H. B. ROBINSON STEAM ELECTRIC PLANT, UNIT NO. 2  
DOCKET NO. 50-261/LICENSE NO. DPR-23

TRANSMITTAL OF CORE OPERATING LIMITS REPORT

**CYCLE 25 CORE OPERATING LIMITS REPORT, REVISION 2**

**SUMMARY OF CHANGES**  
**PRR 00295755**  
**FMP-001**

Figure 4.0, Allowable Deviation from Target Flux Difference

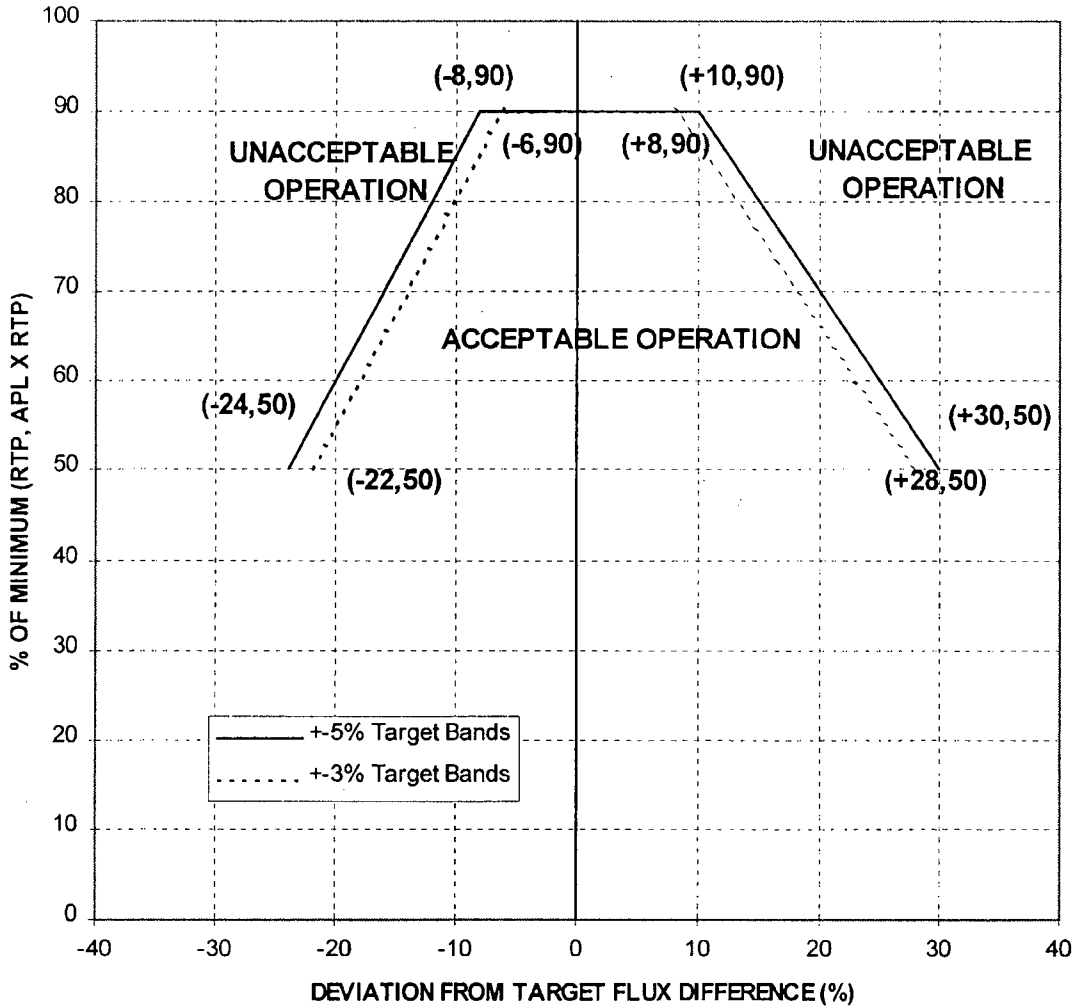
REVISION #	REVISION COMMENTS
24	<p>Per EC 70956</p> <ol style="list-style-type: none"> <li>1. Change procedure revision numbering to "Revision 24"</li> <li>2. Delete Revision 23 Summary of Changes, PRR Number and replace with Revision 24 Summary of Changes, PRR Number</li> <li>3. Add Reference 2.15, EC 70656 Robinson Cycle 25 COLR Change</li> <li>4. Change Attachment 10.1 from COLR "Revision 1" to "Revision 2"</li> <li>5. Change COLR header revision number from "Revision 1" to "Revision 2"</li> <li>6. On Attachment 10.1, Section 1.0, remove the "and" after EC 62926 and replace with a comma.</li> <li>7. Add ", and EC 70956" to Section 1.0 of Attachment 10.1.</li> <li>8. Section 2.7.2(b) replace "4%" with "6%" and add "This shutdown margin requirement shall be met with a minimum boron concentration of 1950 ppm."</li> <li>9. Section 2.7.3(a) replace "that specified in Figure 5.0." with "4% <math>\Delta k/k</math>."</li> <li>10. Section 2.7.3(b) replace "4%" with "6%" and add "This shutdown margin requirement shall be met with a minimum boron concentration of 1950 ppm."</li> <li>11. Section 2.7.3(c) replace "that specified in Figure 5.0." with "4% <math>\Delta k/k</math>."</li> <li>12. Section 2.7.4 replace "1%" with "4%" and add "This shutdown margin requirement shall be met with a minimum boron concentration of 1950 ppm."</li> <li>13. Replace Figure 5.0 Shutdown Margin Versus Boron Concentration with a figure showing a single line for the end of cycle 25 from (0,177) to (157.9, 1.58) and add data labels.</li> </ol>
